SEWAGE DISPOSAL SYSTEM
DEPARTMENT OF HEALTH AND MENTAL HYGIENE

HOWARD COUNTY HEALTH DEPARTMENT
BUREAU OF ENVIRONMENTAL HEALTH
XXXXXXXX 410-313-2640
464-9938

SUBDIVISION Beaufort Park, Block F LOT 5 ROAD 8527 Edenton Road

PROPERTY OWNER Bruce & Madelene Bates

PERCOLATION TEST PLAT
 LOT 6 BLOCK "F"
 PLAT TWO
 BEAUFORT PARK

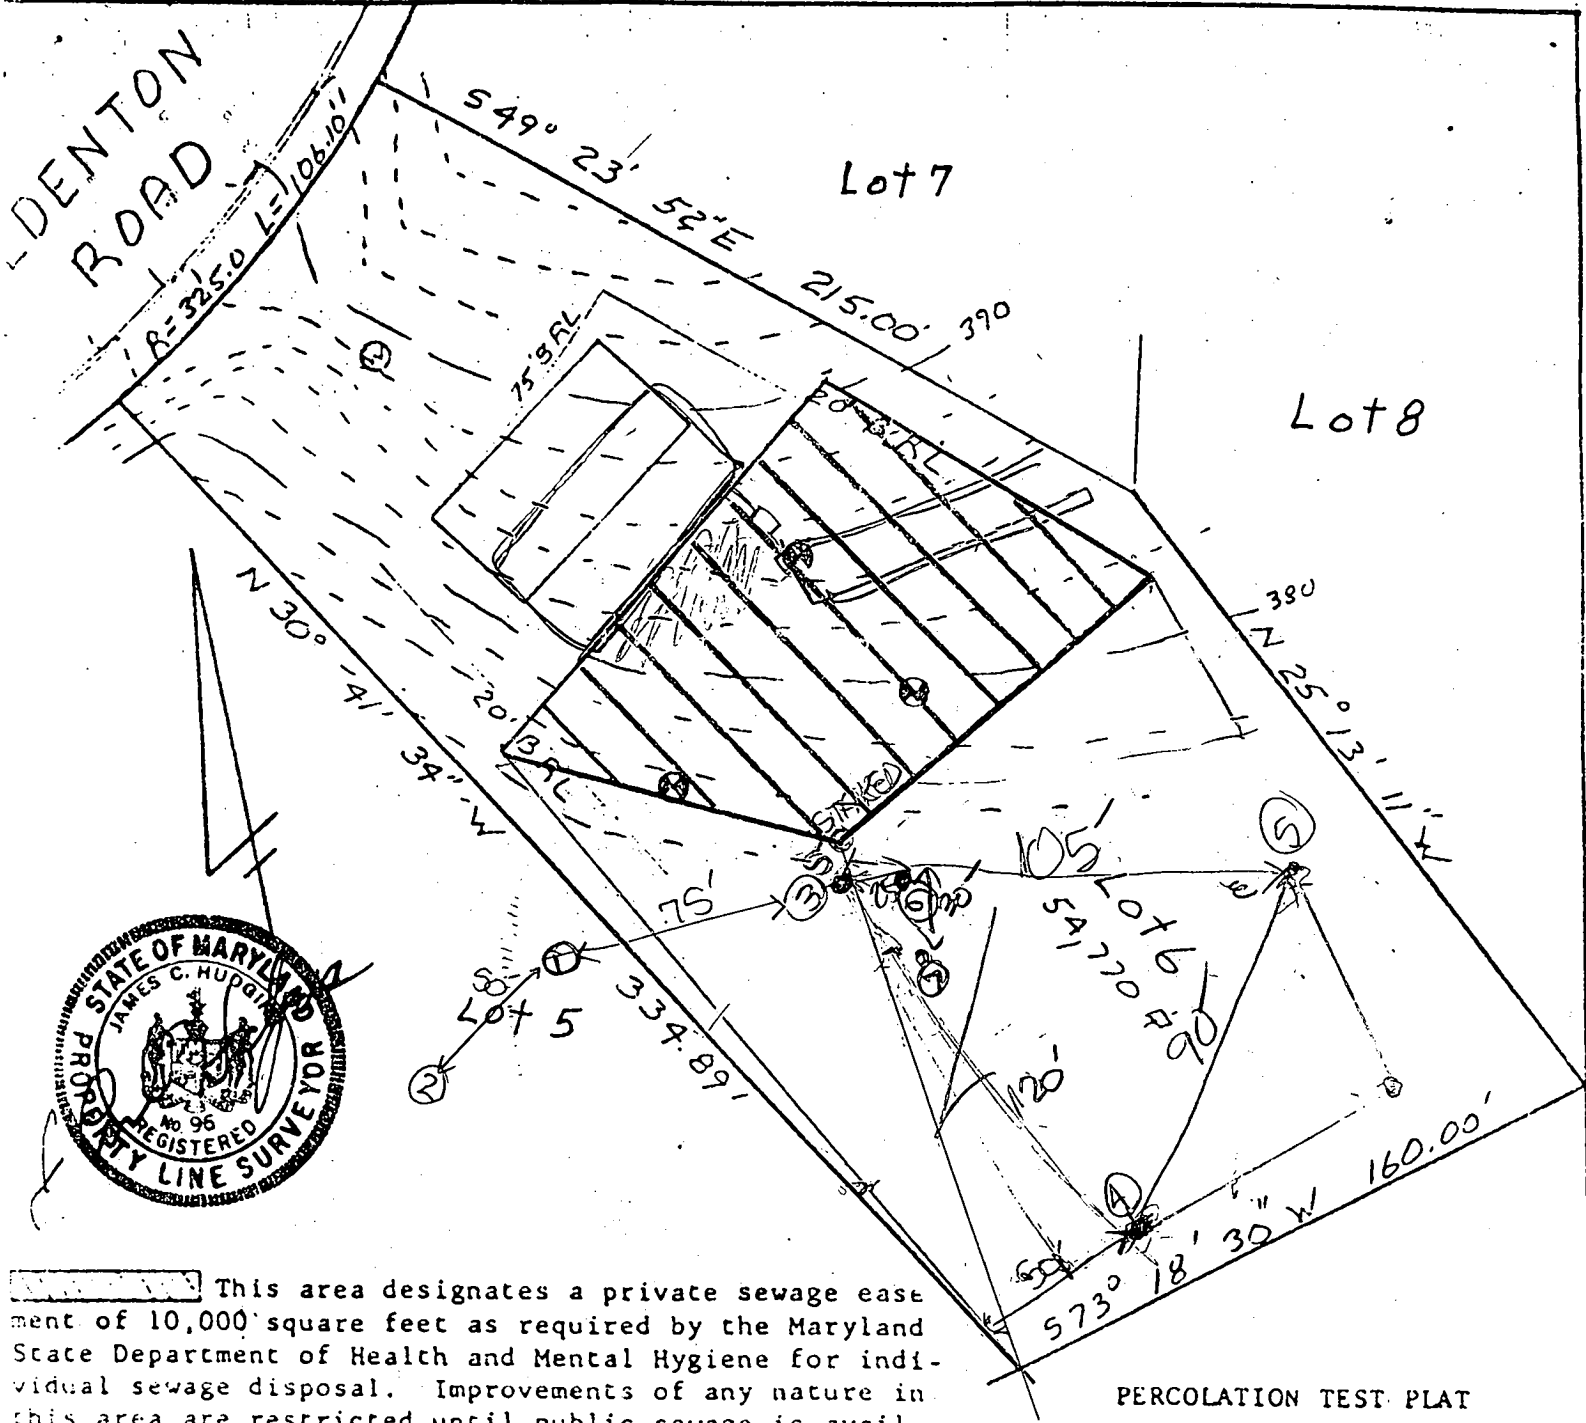
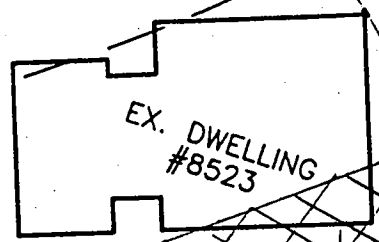
LINE WELL EASEMENT
OK AT ANY WIDTH
10' OR GREATER
- ONLY NEEDS TO
ACCOMMODATE
A "TRENCH"

ADJUSTMENT TO
SEPTIC EASEMENT
ACCEPTED AT
THIS TIME,

WILL NEED
MORE
FINAL
PLAN
FOR
FINAL
APPROVAL

Subject 8527 Edenton Rd., Fulton, MD 20759

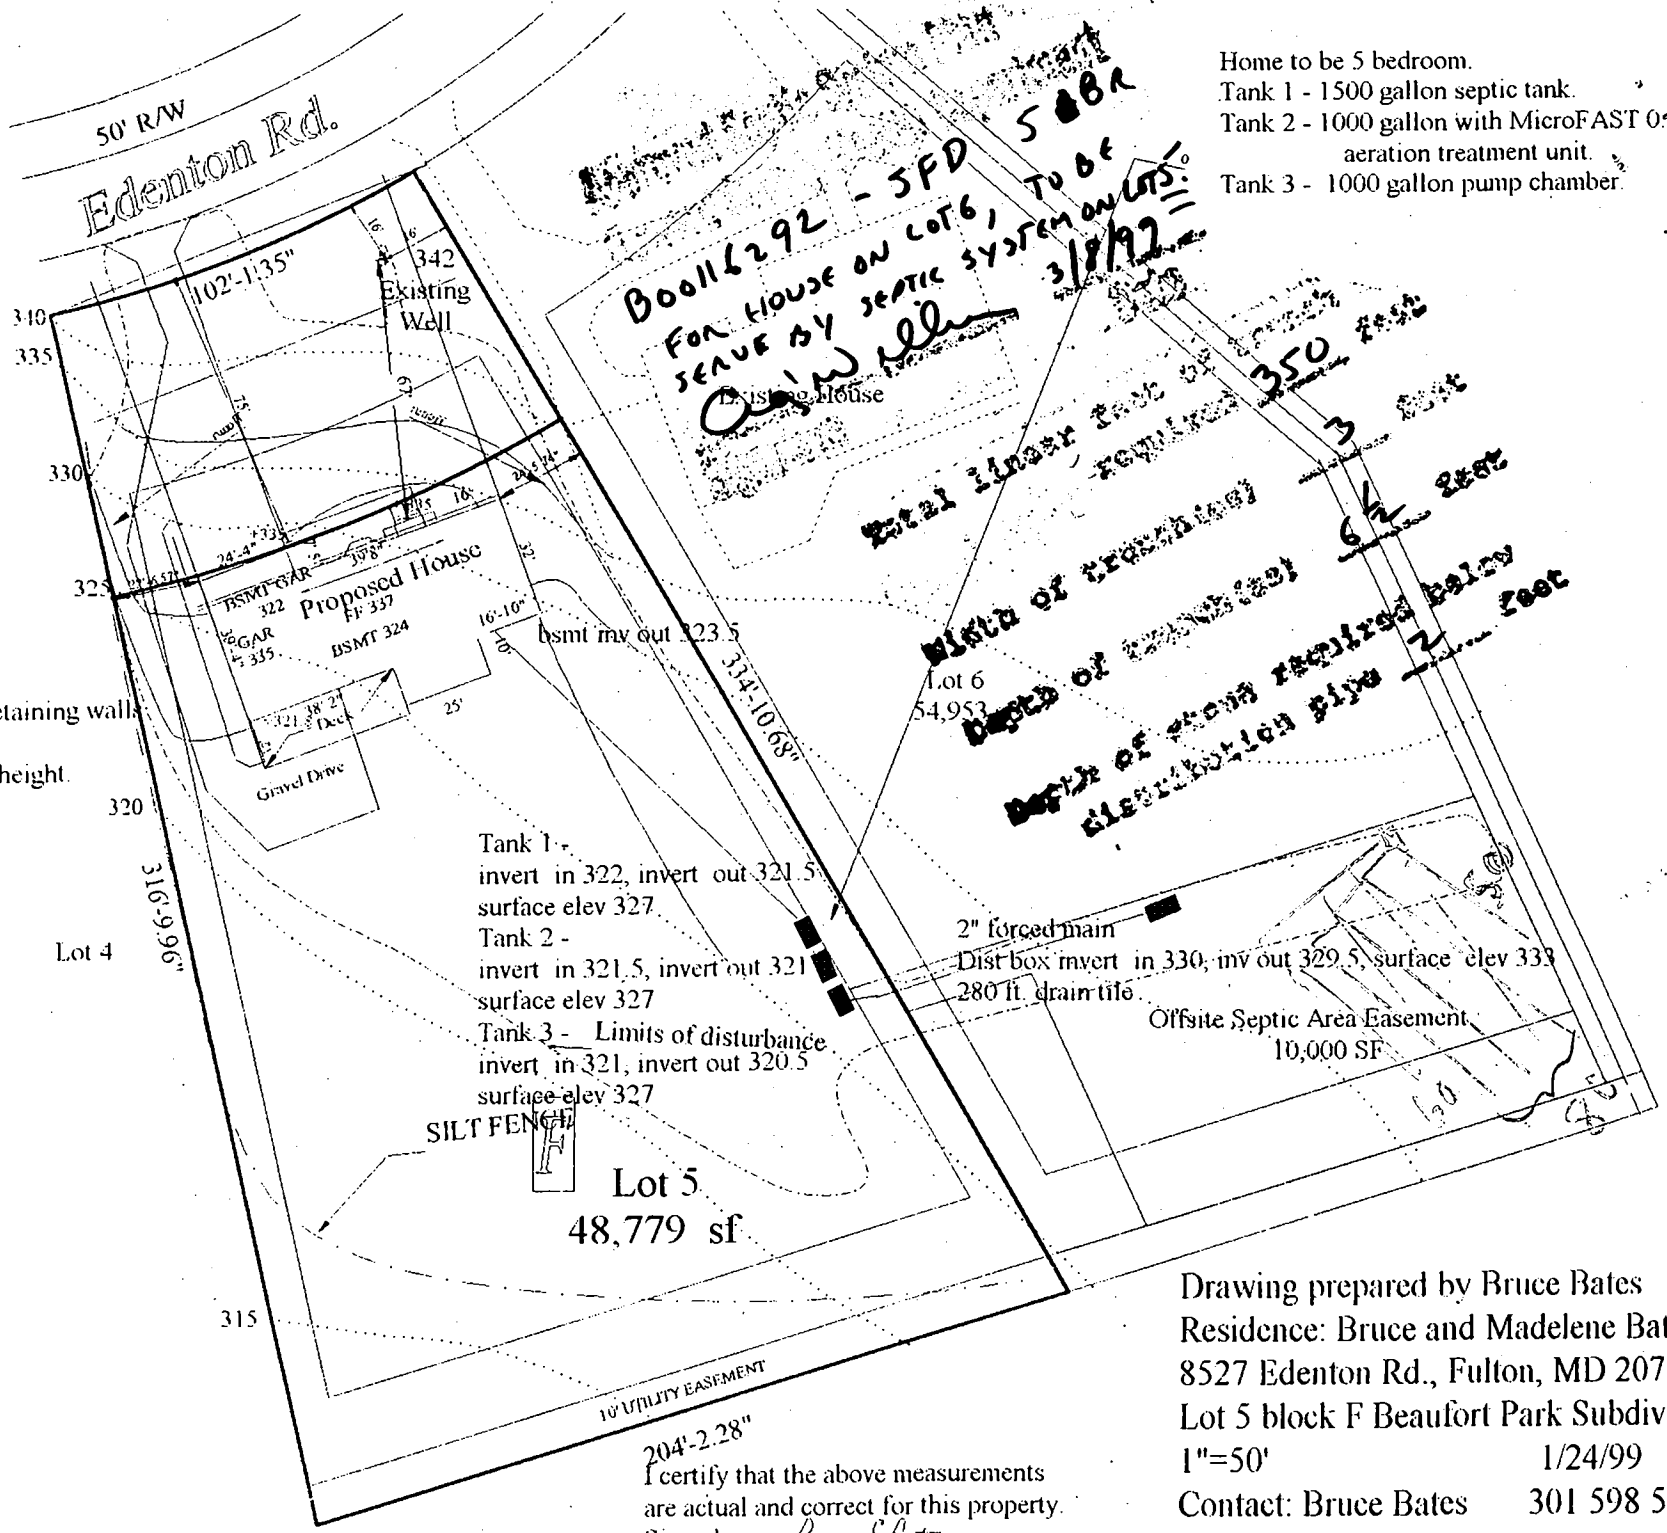
- PLANS OK; HOW ABOUT SERVICE AGREEMENT TO CONFIRM UNIT IS WORKING PROPERLY?

- HAVE YOU RECORDED THE EASEMENT WITH THE DEEDS OF BOTH PROPERTIES?

IF SO - SEND A COPY; IF NOT, SUGGEST YOU PRESENT LANGUAGE FOR REVIEW PRIOR TO RECONSTRUCTION.

THEN ELIGIBLE TO ISSUE SEPTIC PERMIT (\$180 PERMIT FEE DUE FROM CONTRACTOR, OR YOU) CORNERS OF SEPTIC AREA SHOULD BE STAKED PRIOR TO SYSTEM INSTALLATION. 9/1/99 (CW)

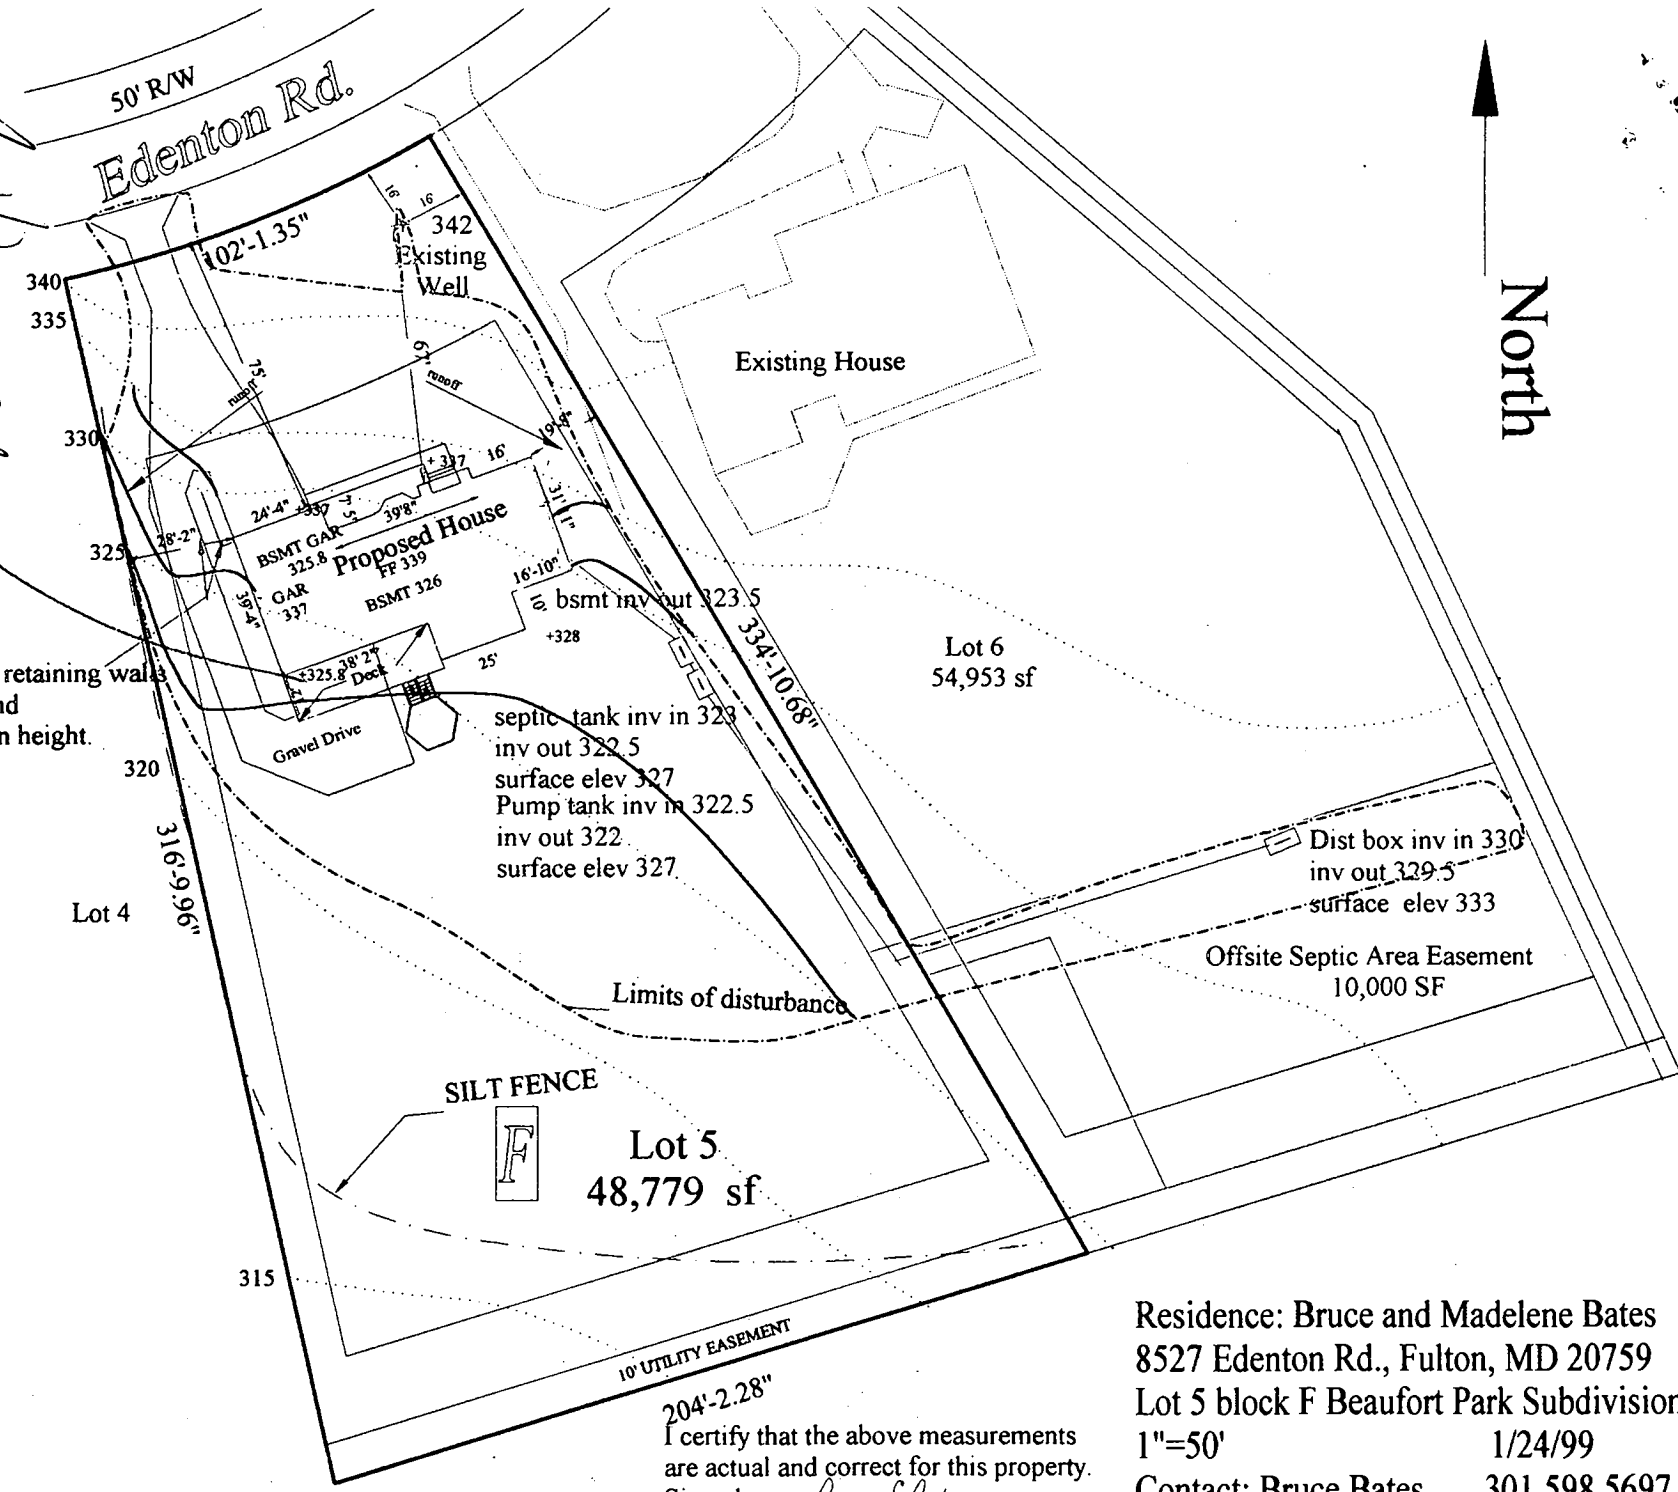
PROPOSED DECK
 OK-NO IMPACT
 PUR 4/17/00

REVISED PERCOLATION PLAT
LOTS 10-12
BEAUFORT PARK
SECTION FOUR / AREA TWO
FIFTH ELECTION DISTRICT
HOWARD COUNTY, MARYLAND.
SCALE : 1" = 30' DATE : JUNE 1993

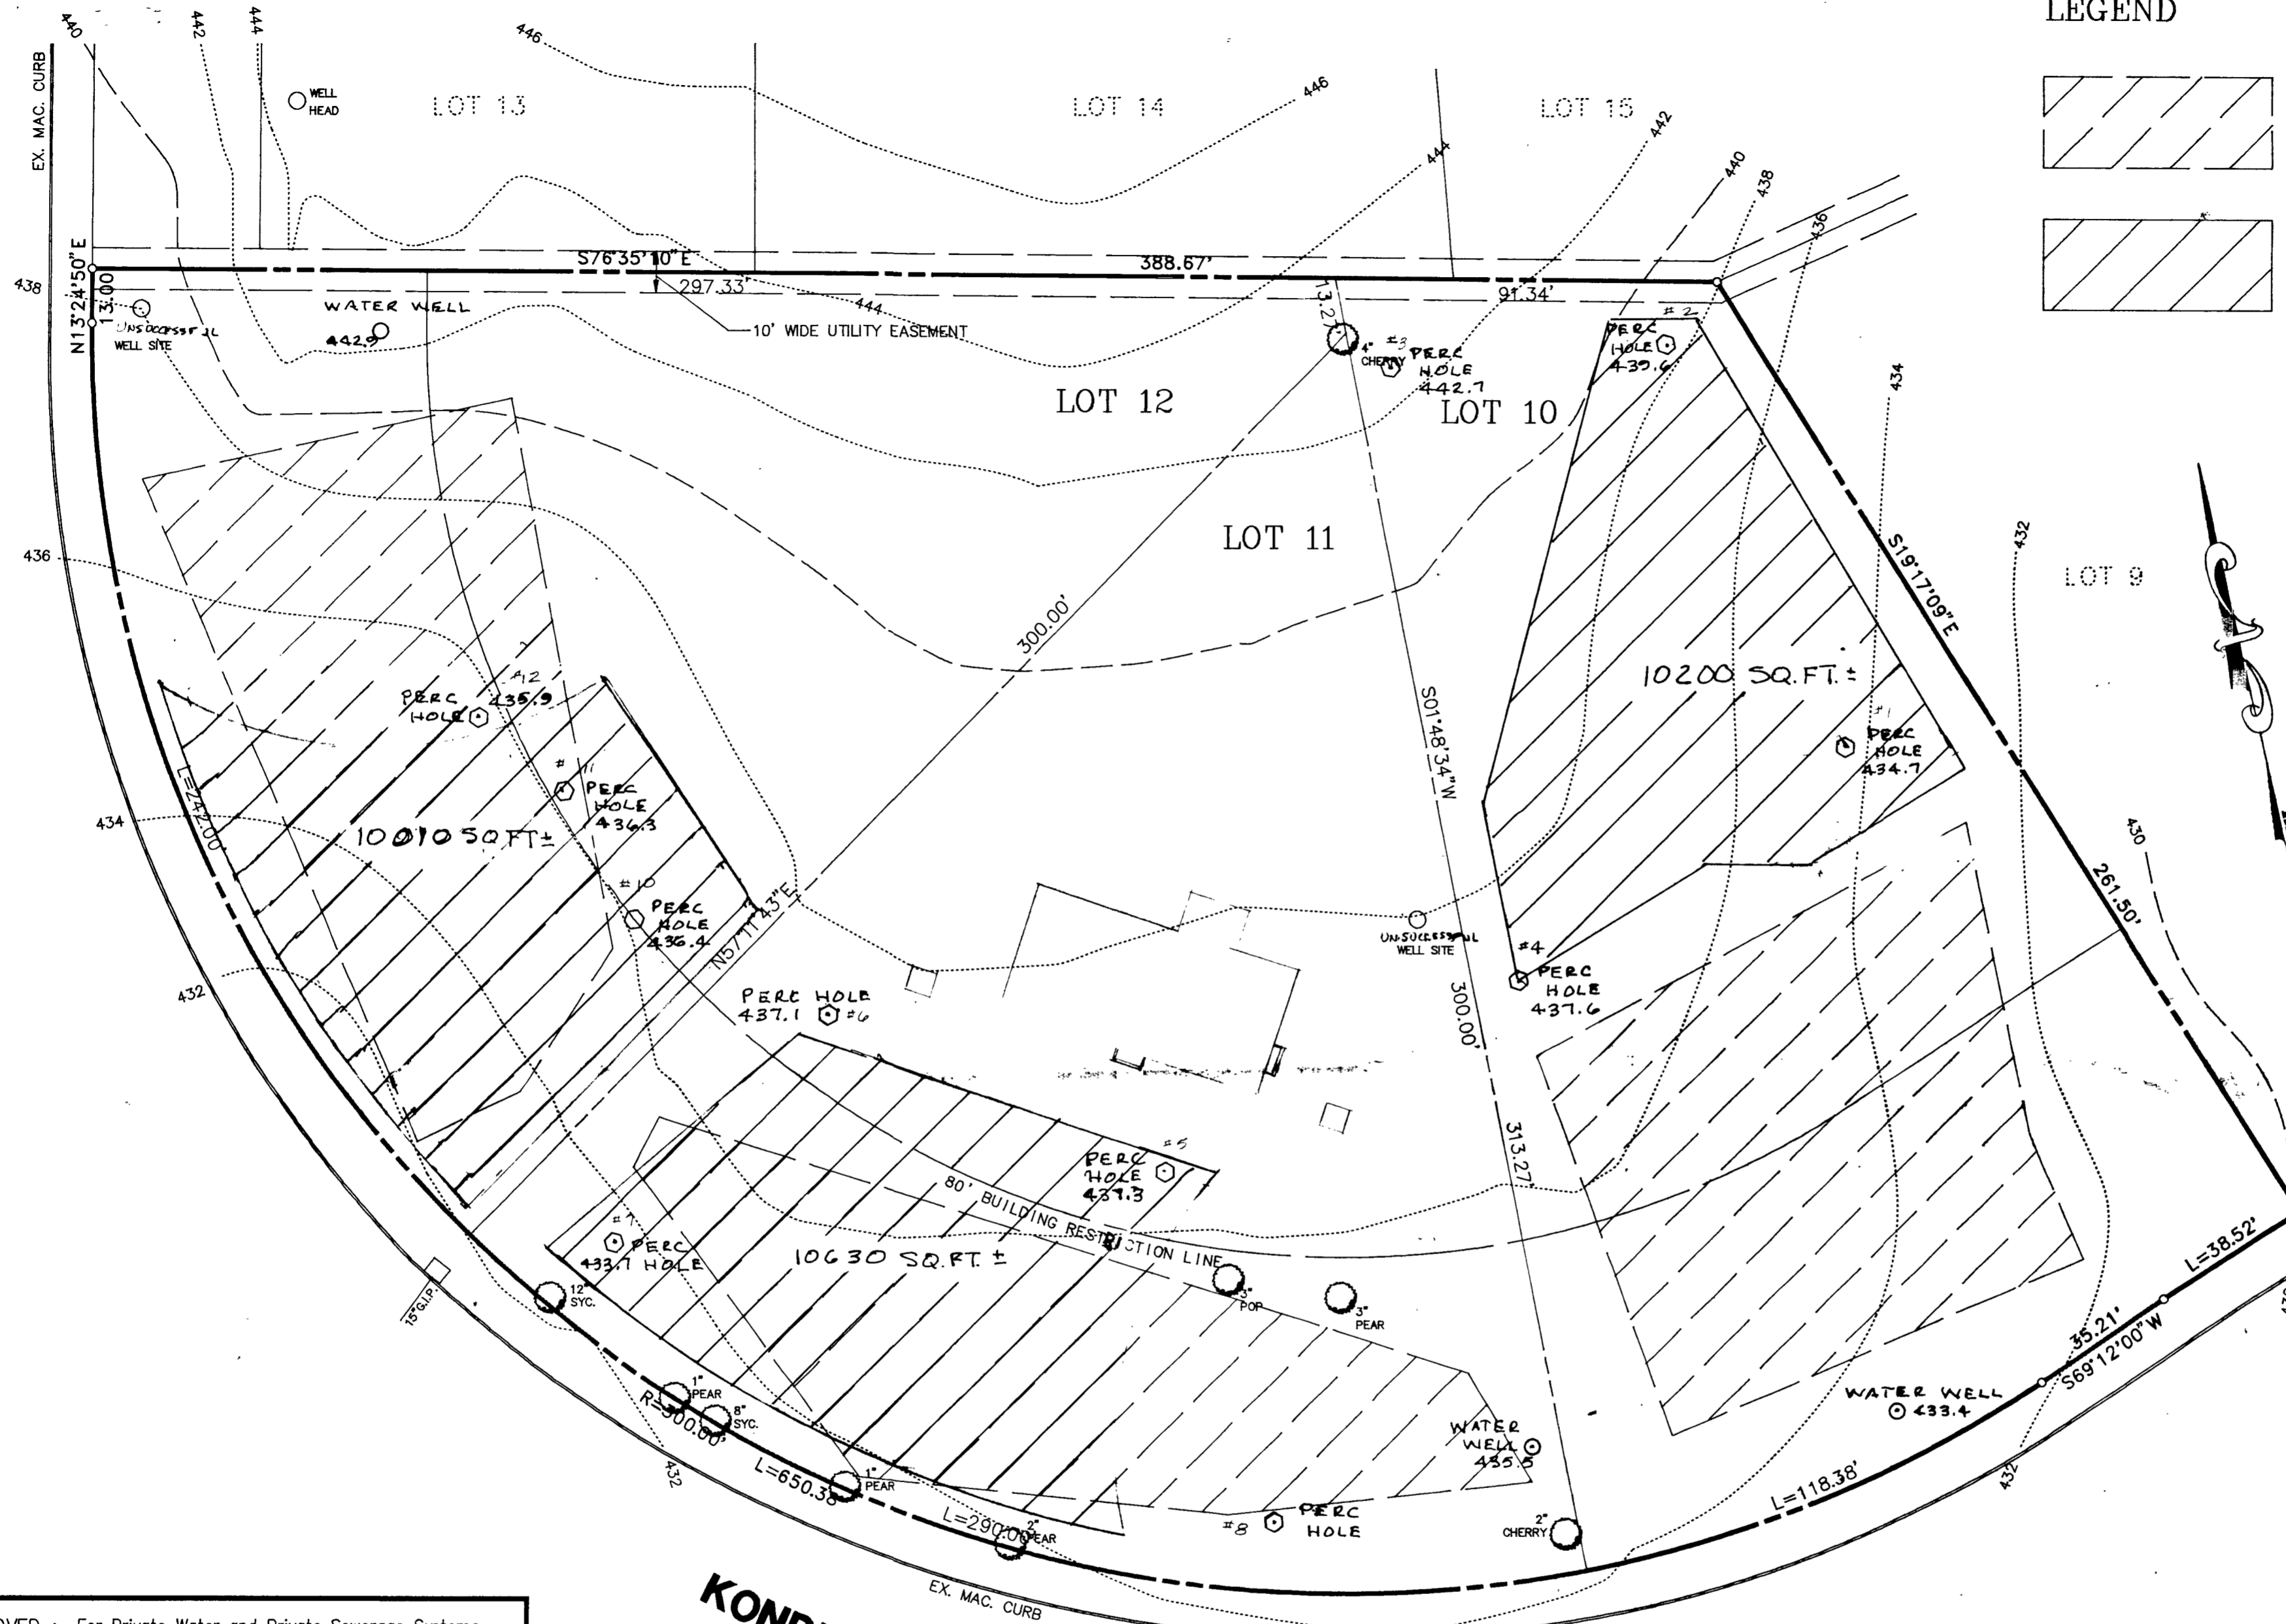
- indicate that the intent of the document is to modify previously approved septic areas to accomodate existing wells;
- clarify that "existing sewage easements" are being abandoned via approval of this document;
- indicate that all relevent wells and septics on the subject properties, and within 100' of the property boundaries have been shown.
